# TENTATIVE SUBDIVISION MAP EXHIBIT
# COUNTY OF SAN DIEGO TRACT NO. 5295 RPL 7

VISTA FIRE
PROTECTION DISTRICT

**RE: Request of Agency Recommendation**
**TM5295 RPL6**
**APN: 184-080-08**
**Address: Sugarbush & Buena Creek**
**Vista, CA 92084**

RE: TM 5295 RPL-7 Sugarbush
Fire Protection Plan (FPP)
Vista Fire Protection District
**Fire Protection Plan - incomplete**

## DETAIL: CLEVELAND TRAIL

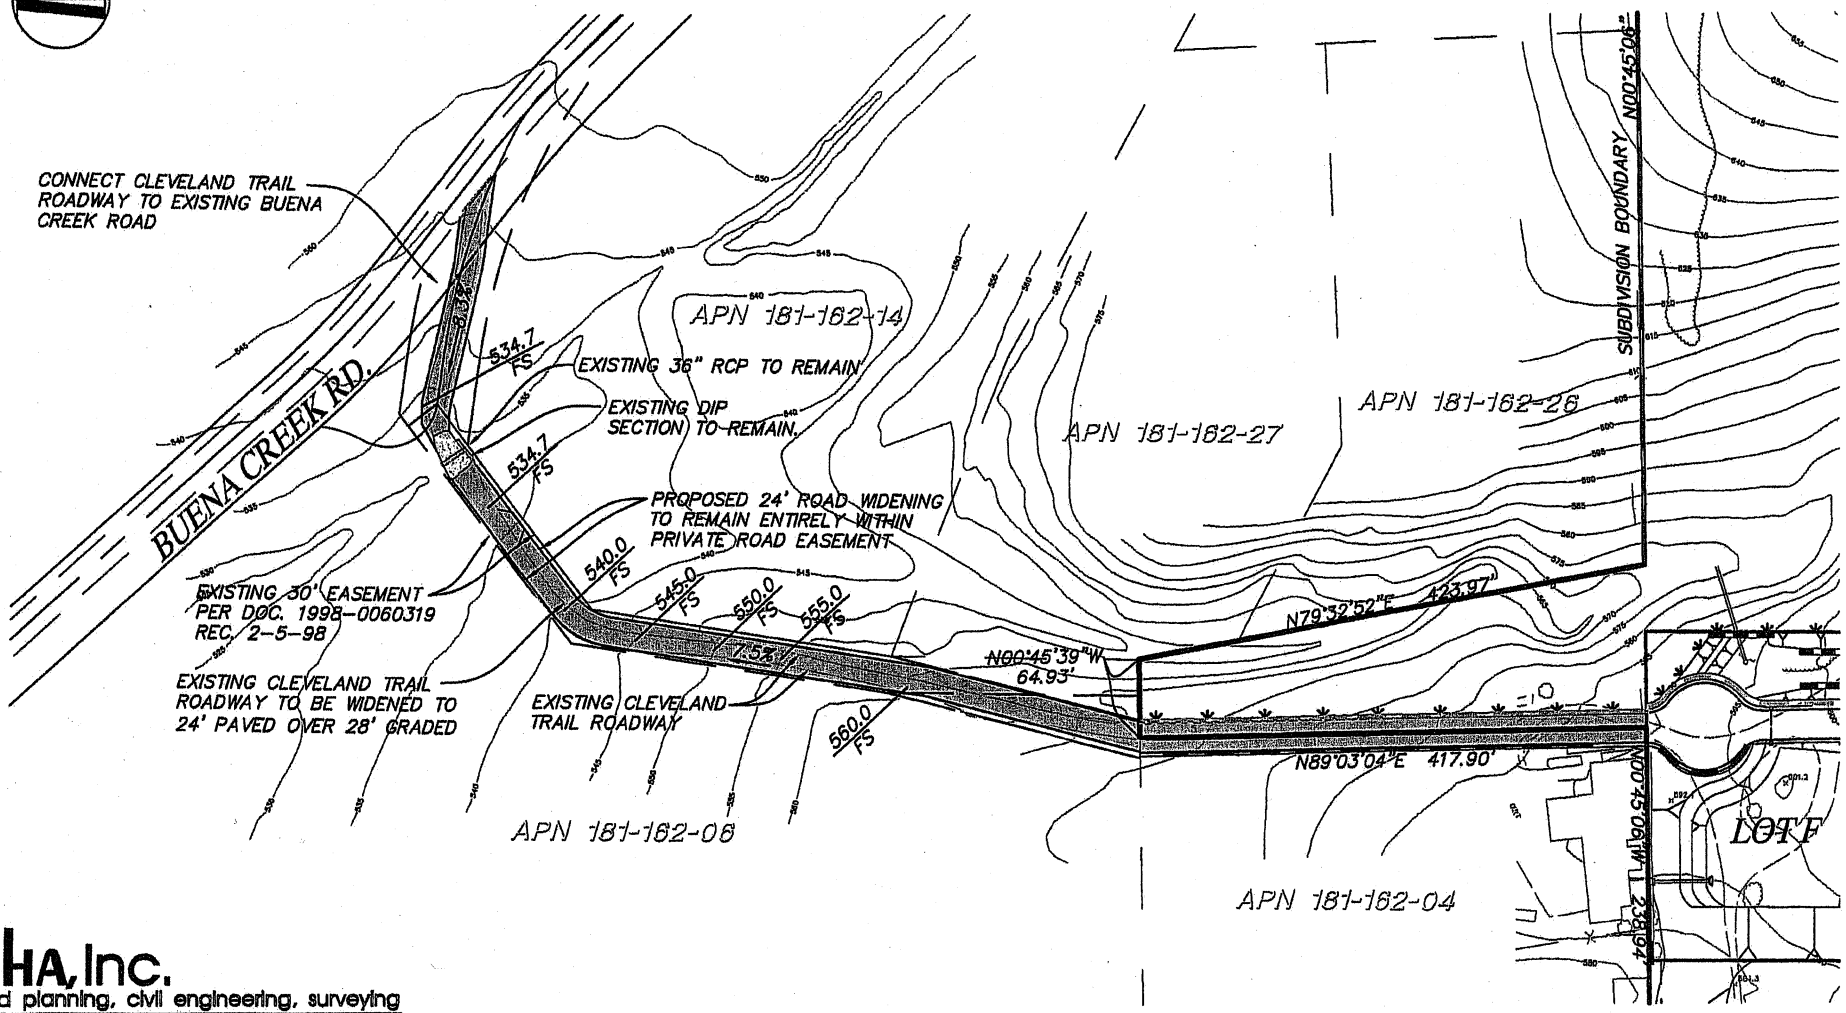
Pursuant to our meeting today, we are forwarding this letter and a drawing of the Cleveland Trail proposed improvements for your review and approval.

I have reviewed your letter and the attached detail for Cleveland Trail road improvements dated April 14, 2009 (copy attached). It accurately summarizes our conversation related to the improvement of the Cleveland Trail crossing to Buena Creek Road.
